PORT MACQUARIE-HASTINGS
COUNCIL

Development Assessment Panel

Business Paper

date of meeting: Thursday 2 September 2021

Figure 2: Plan Extract showing Landscaped Street frontage

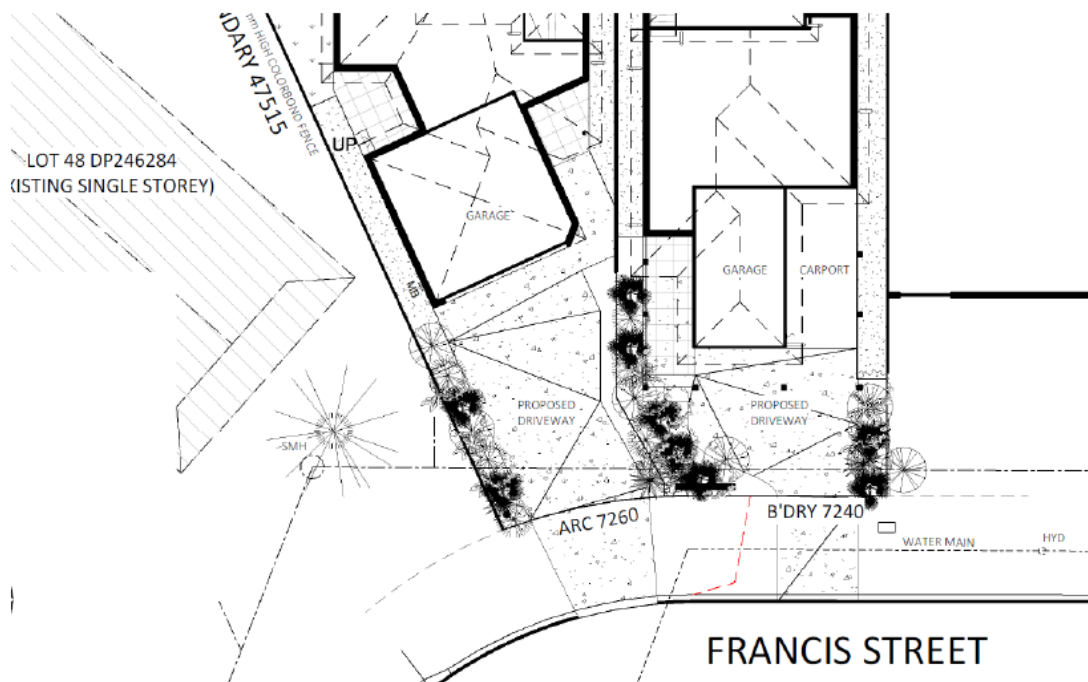
Having regard to the narrowness of the street frontage, it is noted that there is very limited opportunity for pedestrians or motorists to be impacted by the garage doors proposed for this property, considering the amendment now provides for a only a double garage and single garage door, with extensive screening, greater than required setbacks, the double garage being at an angle to the street frontage which minimises any visibility, and the fencing, landscaping and other design elements discussed above.
